Activbody Inc completed a minor improvement change for the device, to replace one internal plastic material: The new frame plastic material has improved elasticity, to allow easier opening of the device upper case. This improves user experience when opening the device, and makes the plastic snaps more flexible. The change is as follows:

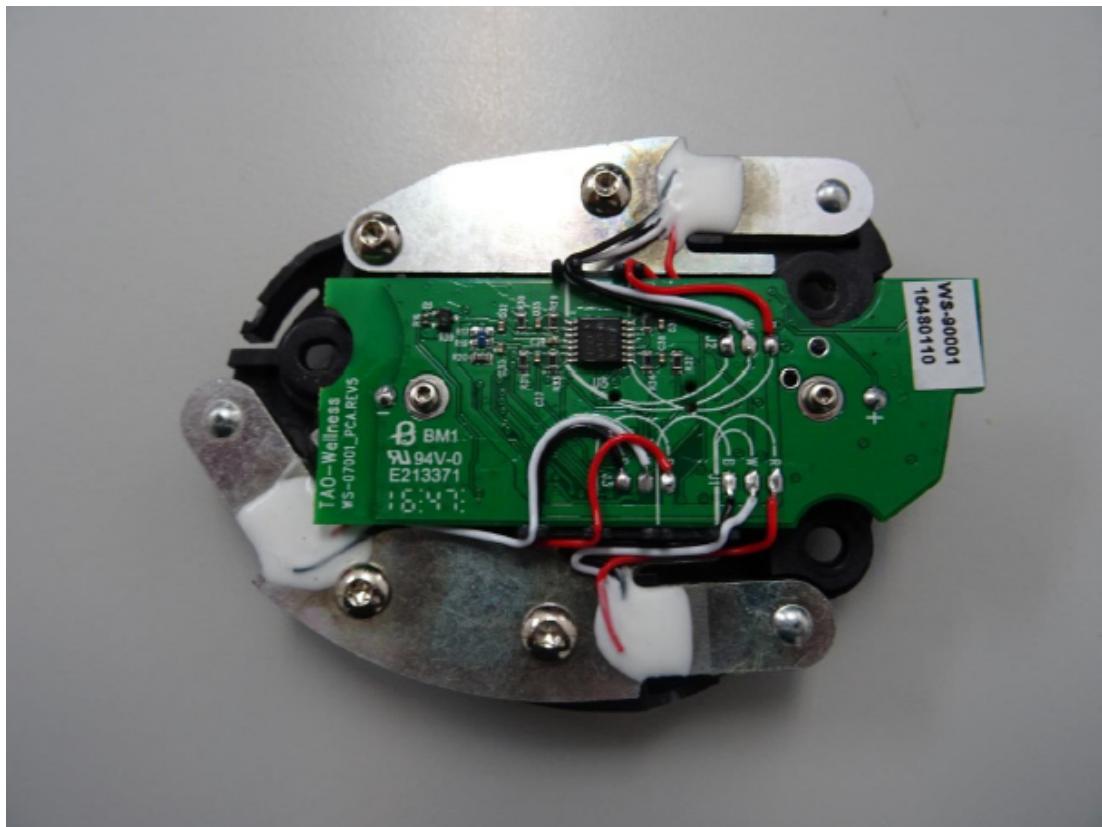
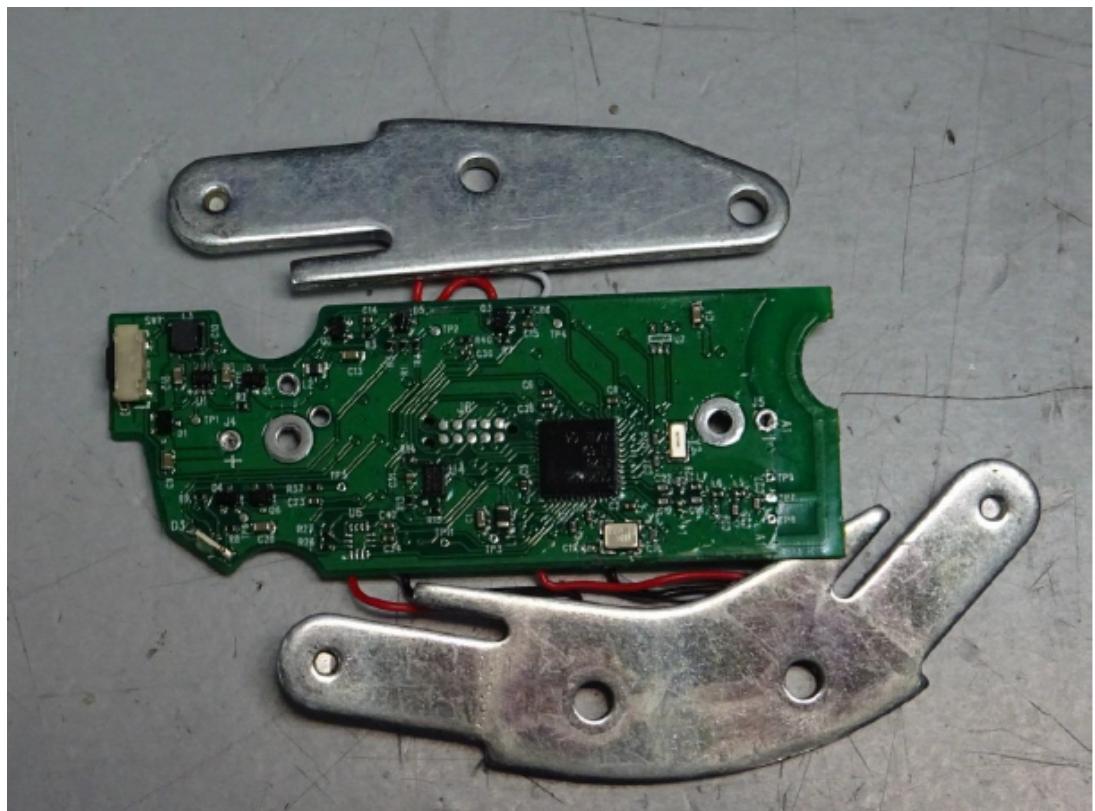
Change from: Glass Filled (GF) ABS plastic with 20% glass content,
To: Glass Filled (GF) Polycarbonate (PC) plastic with 10% glass content
